# CITY OF ALBUQUERQUE

RE: **Jiffy Lube Expansion**  
**8305-8313 Menaul NE**  
**Grading Plan Stamp Date: 9/4/19**  
**Drainage Report Stamp Date: 9/4/19**  
**Hydrology File: H15D068**

Based on the submittal received on 9/4/19, this project cannot be approved for Plat or Building Permit until the following are corrected:

ENGINEER'S SEAL	JIFFY LUBE 2301 WYOMING BLVD. NE GRADING & DRAINAGE PLAN	DRAWN BY BF DATE 9/4/2019 2018016_GR
	RONALD R. BOHANNAN P.E. #7868		
		TERRA WEST, LLC 5571 MIDWAY PARK PLACE NE ALBUQUERQUE, NM 87109 (505) 858-3100 www.tierawestllc.com	SHEET # <b>C1</b> JOB # 2018016

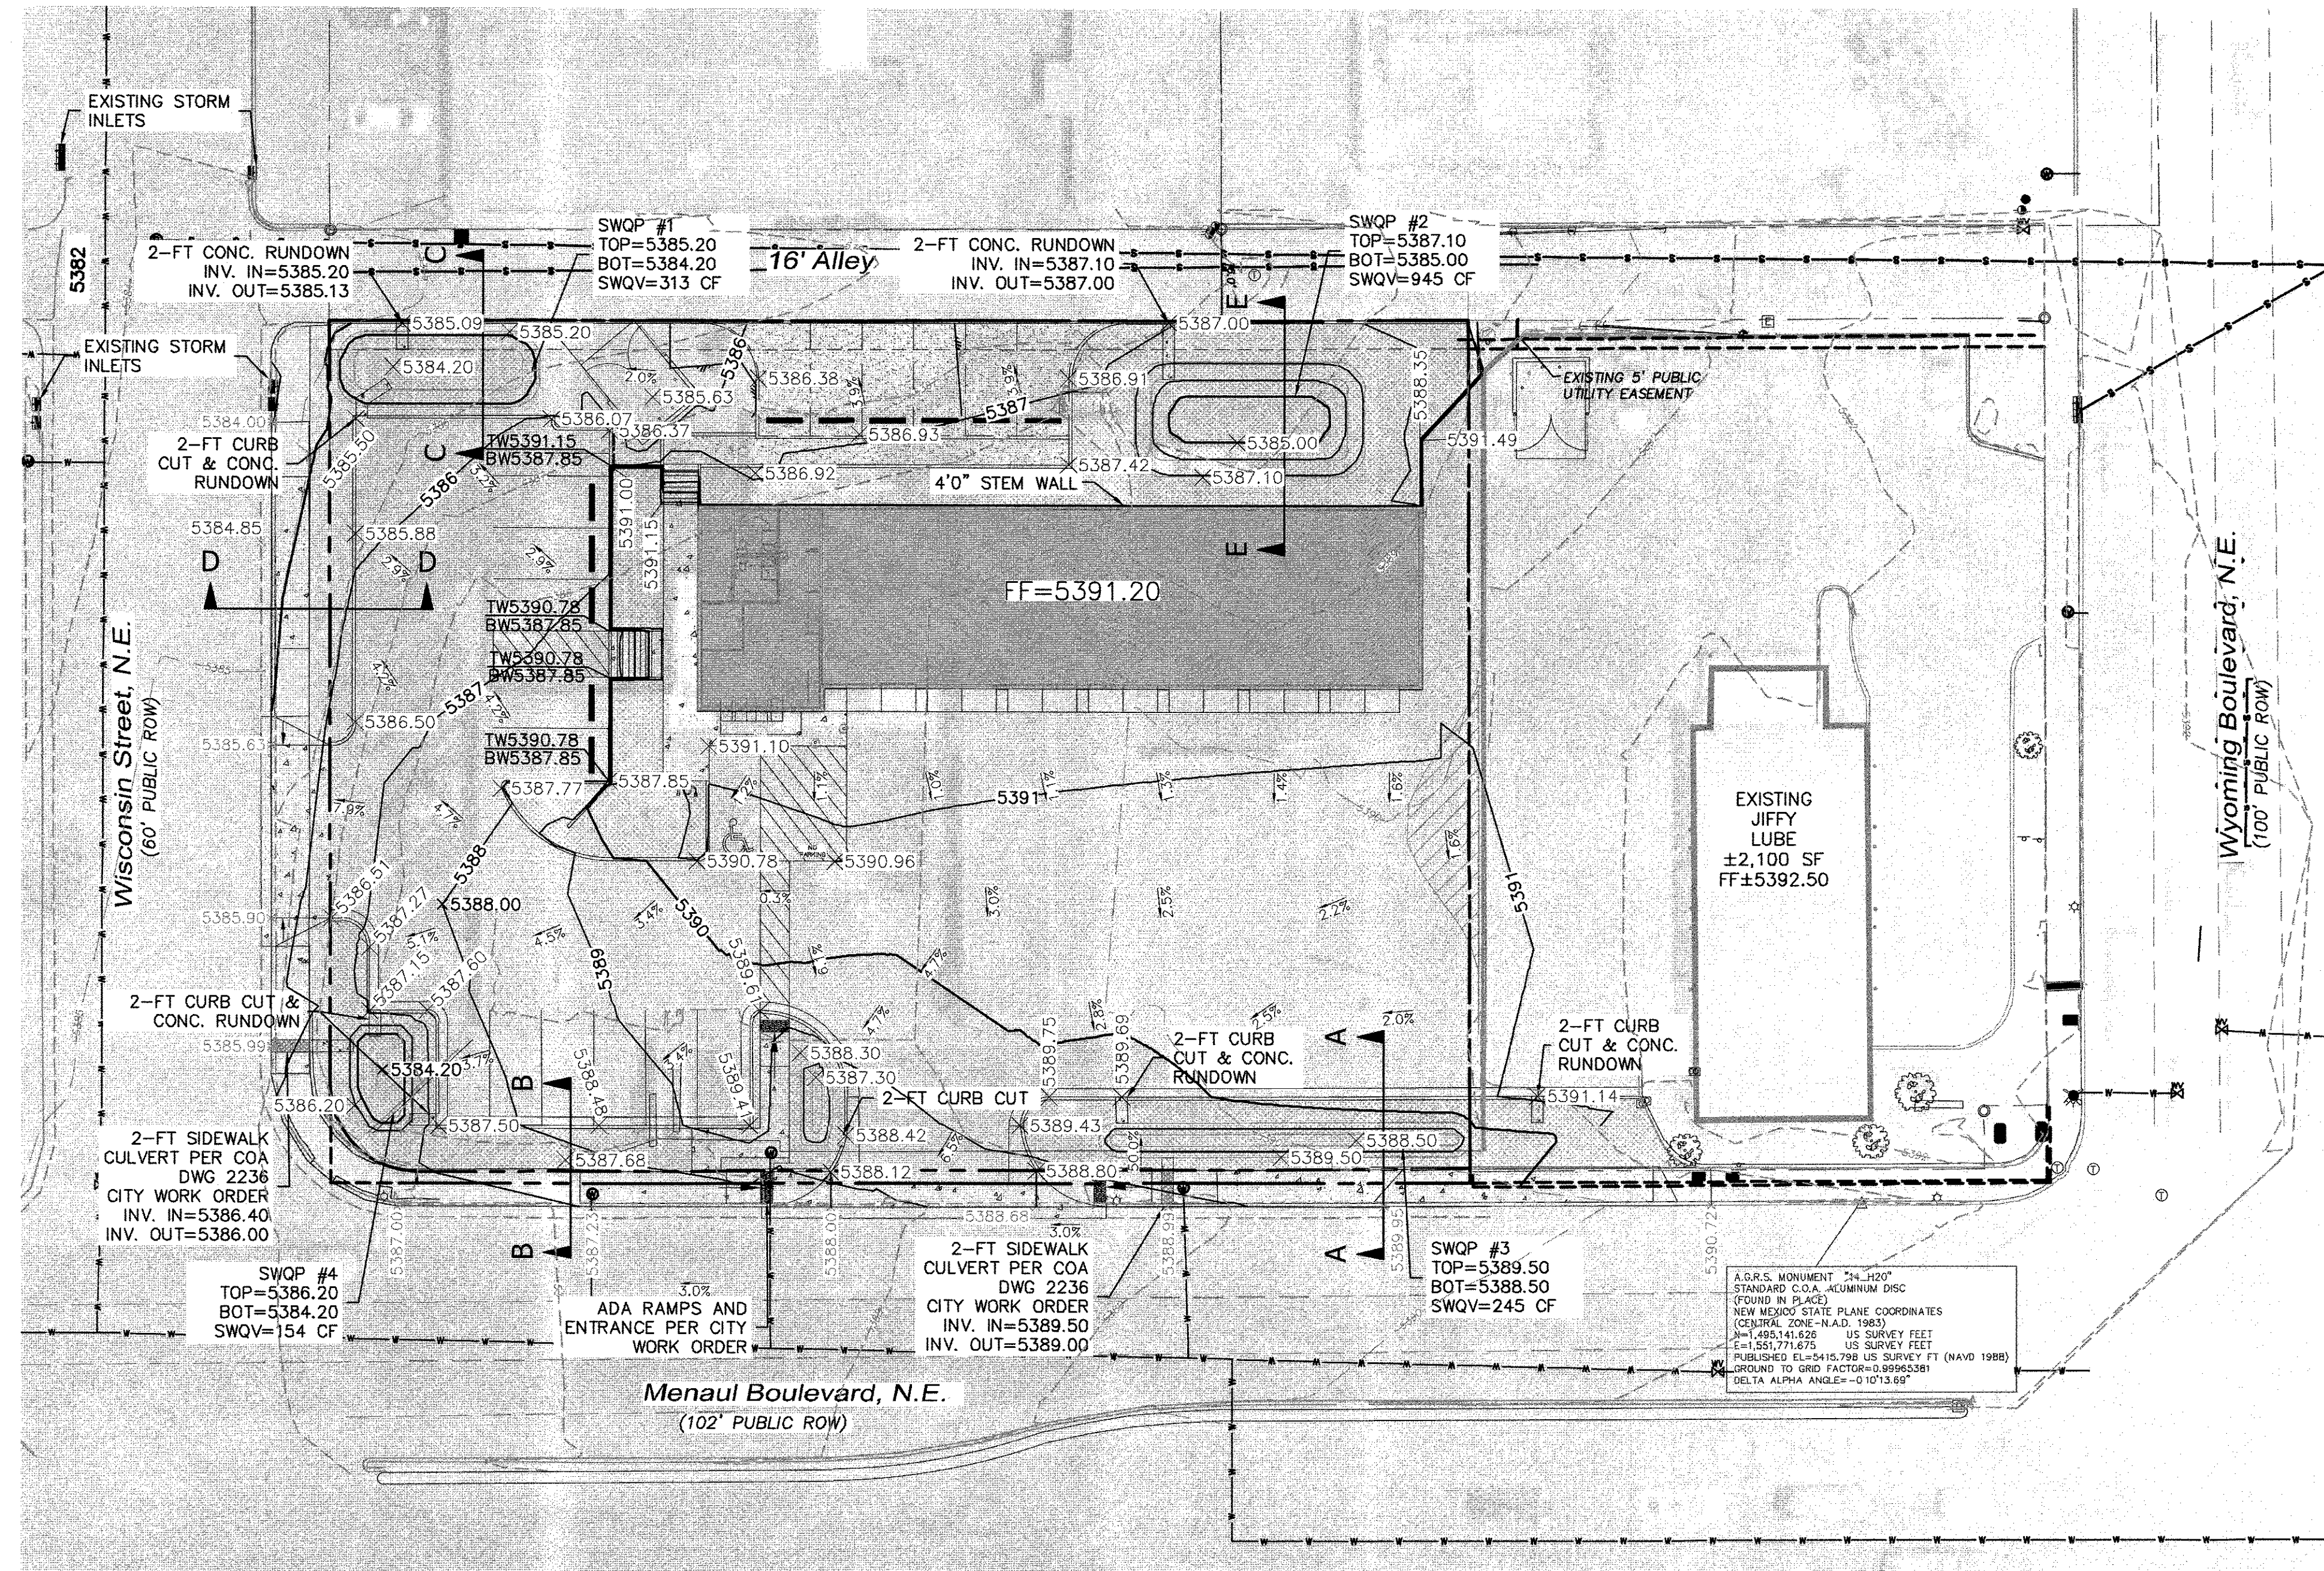
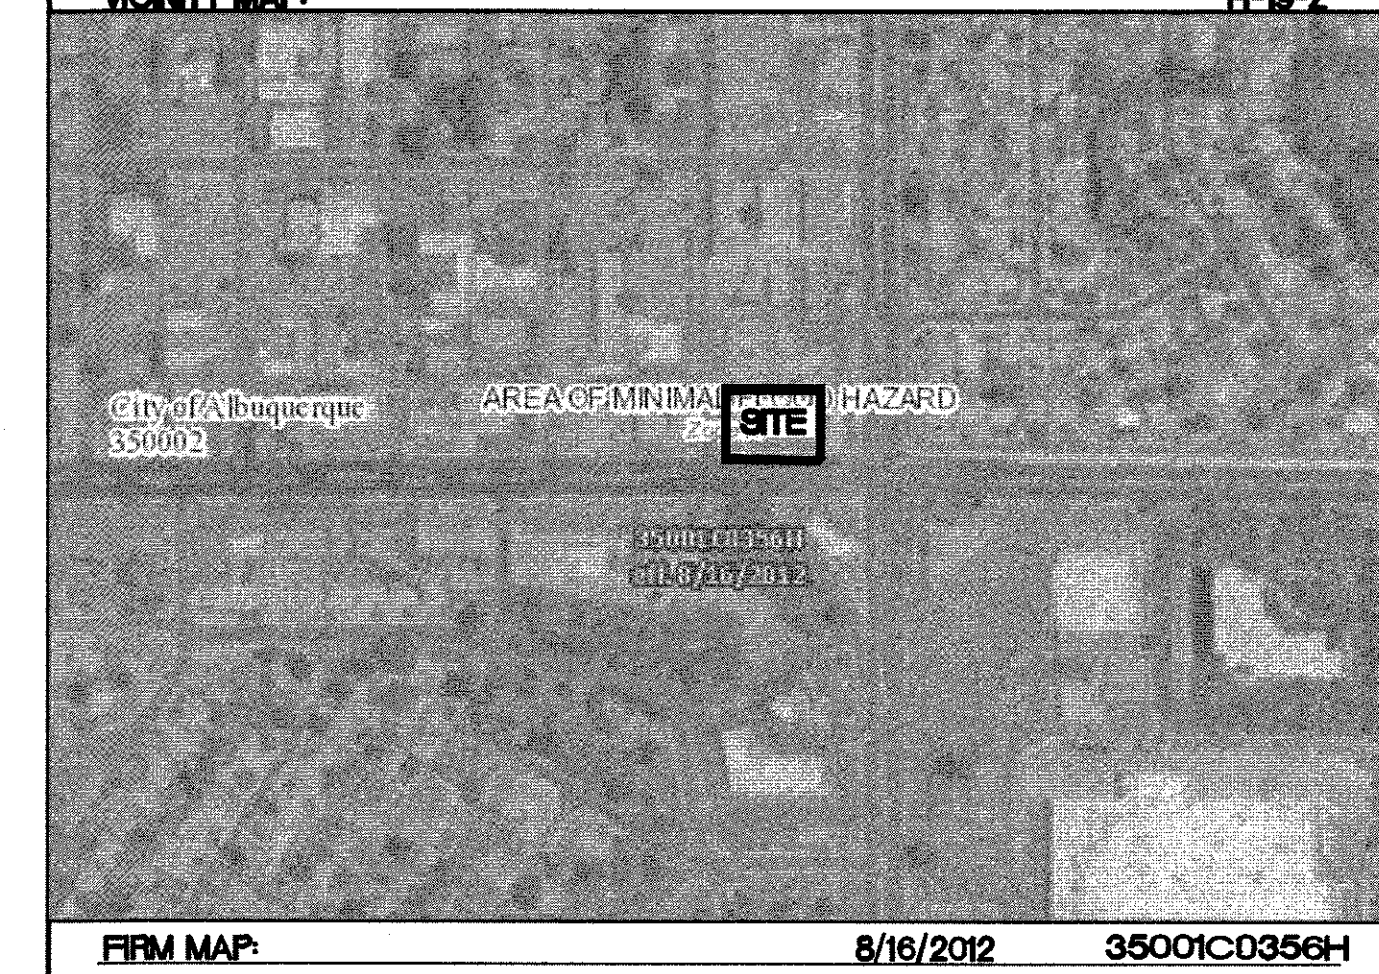
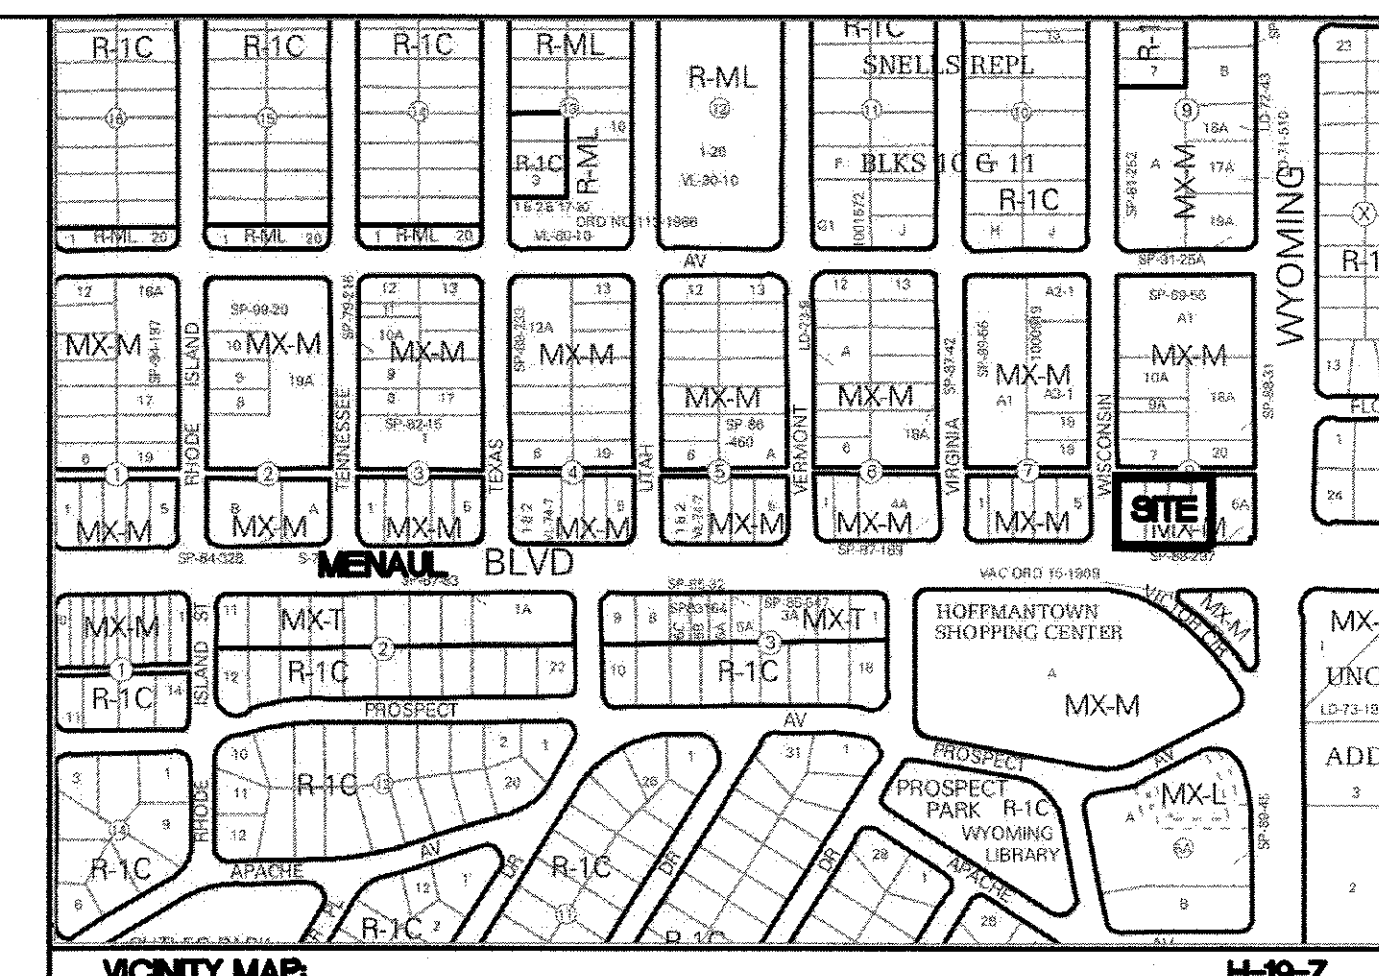
1. Remove the SO-19 notes (C1).
2. List the sidewalk culverts on the infrastructure list.
3. On the Plat, provide a drainage easement over the ponds and annotate using the [Plat Drainage Easement Note](#). This note replaces the need for a separate drainage covenant (alternatively, you could do a drainage covenant, recorded prior to C.O).
4. For automotive repair centers, demonstrate *control of oil from vehicle parking areas* per DPM Chapter 22.9.E, Table 1. SWQPs 1, 3, and 4 will need outlet structures designed to trap oil during the 100-yr and smaller storms. Ideas may include a 90<sup>0</sup> downturned pipe elbow or steel plate skimmer around the back of the sidewalk culvert. SWQP 2 is fine since it doesn't serve any parking area.
